DESCRIPTIVE REPORT (HYDROGRAPHIC)

Type of Survey Hydrographic
Field No. ECFP-1856
Office No. H-8367 & Ad. Wk.

State Rhode Island
General Locality Narragansett Bay
Locality Entrance Narragansett Bay

HYDROGRAPHIC SURVEY H-8367, FIELD NO. ECFP-1856
Entrance Narragansett Bay, Rhode Island

WHALE ROCK BEACON, 1940

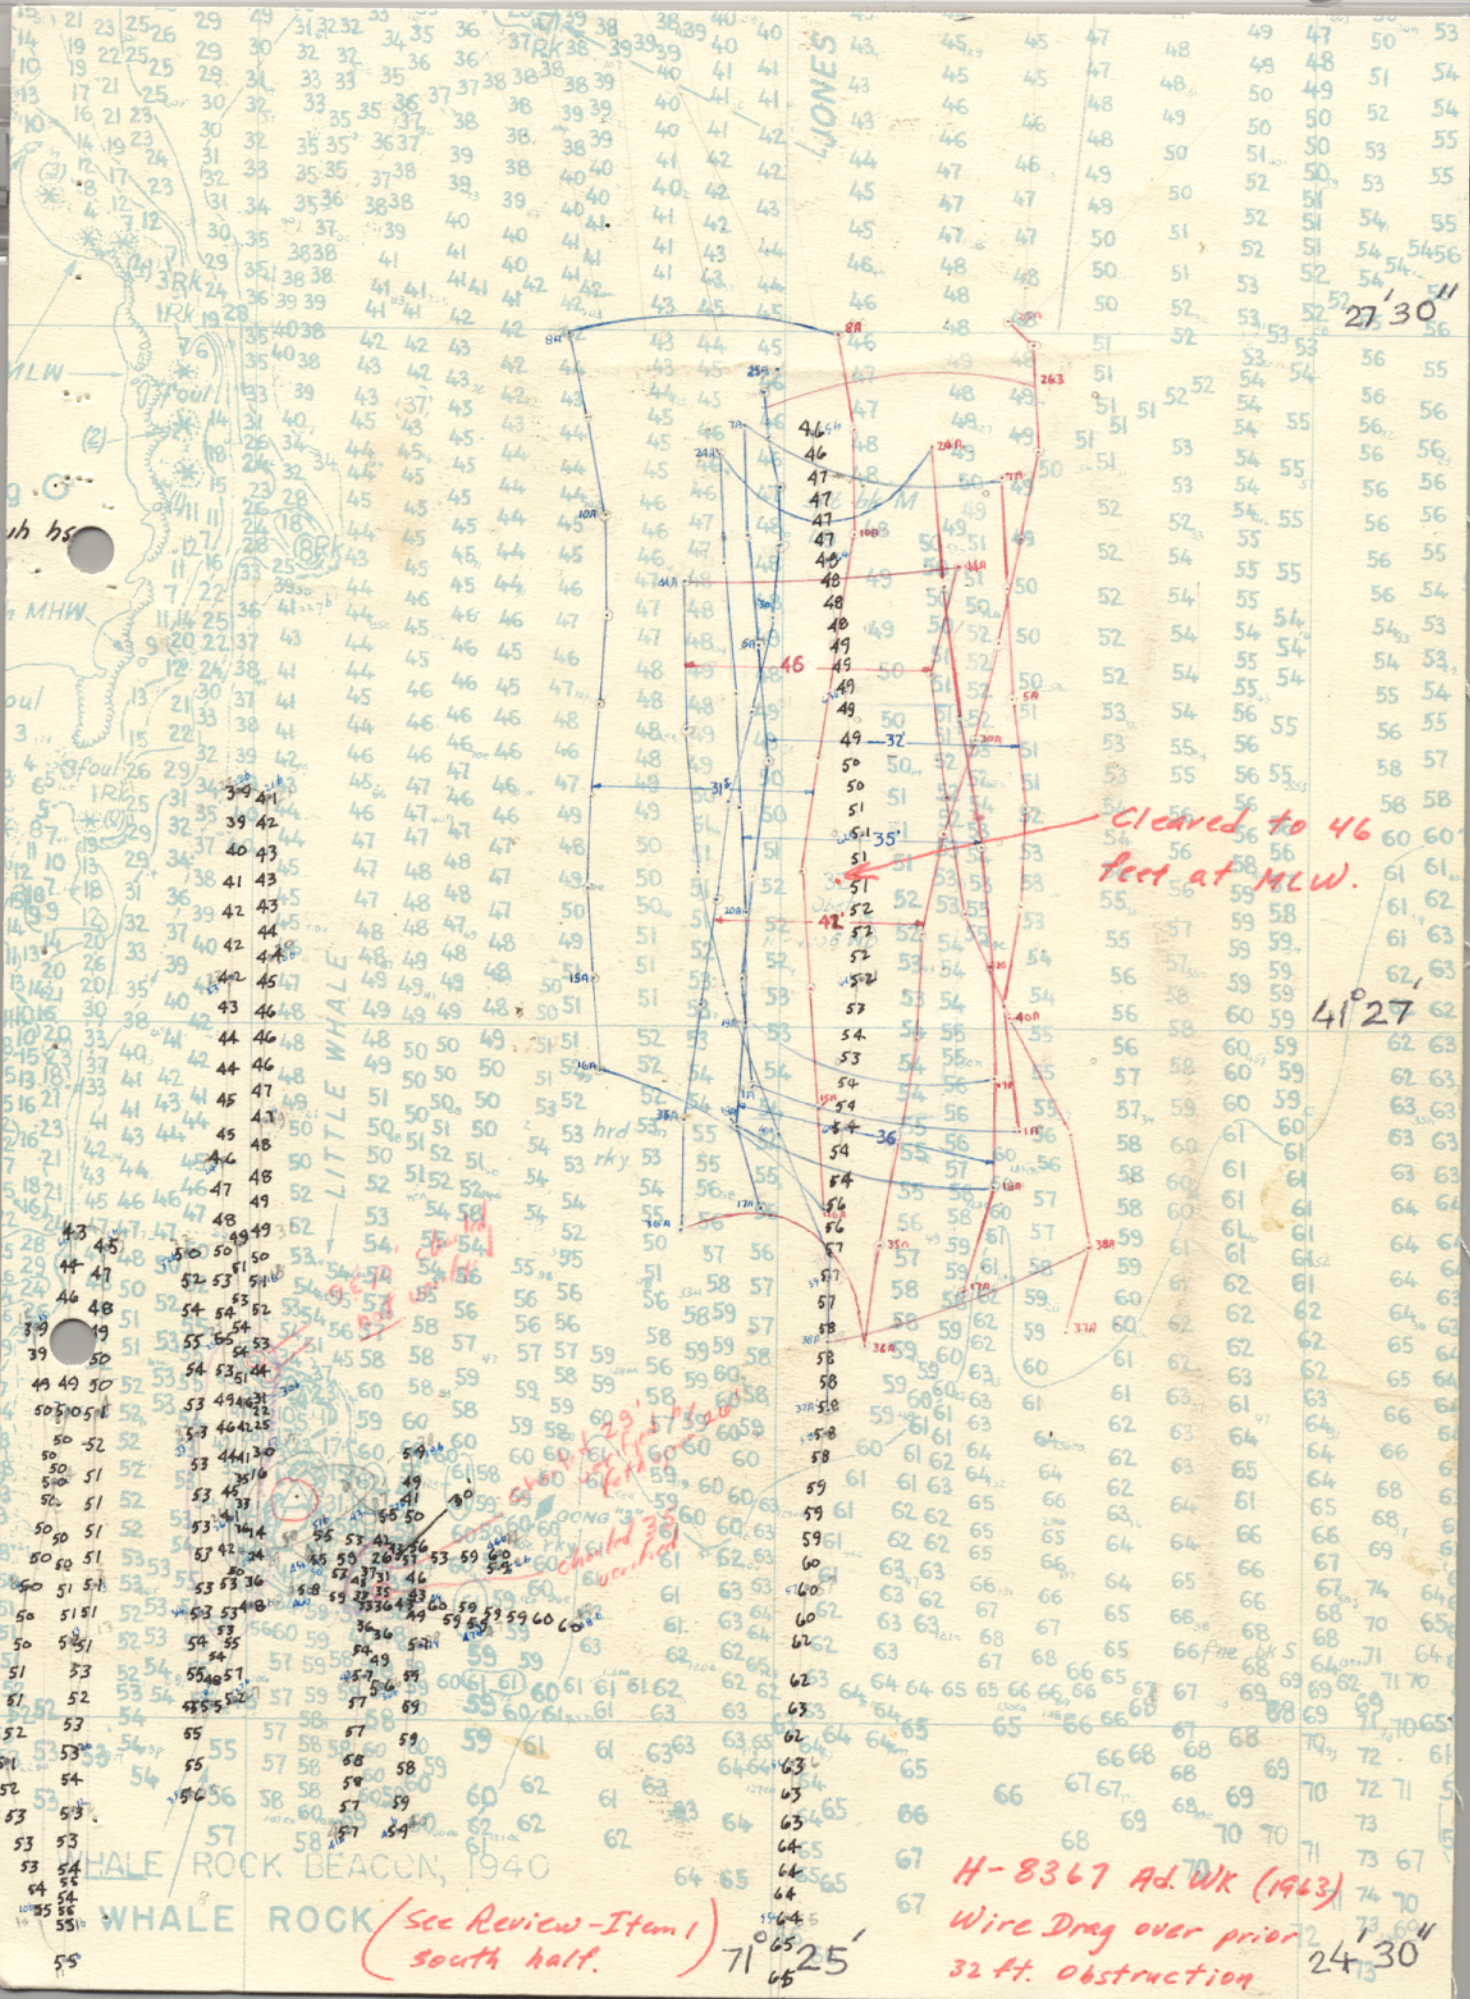
WHALE ROCK (See Review-Item 1)
south half.
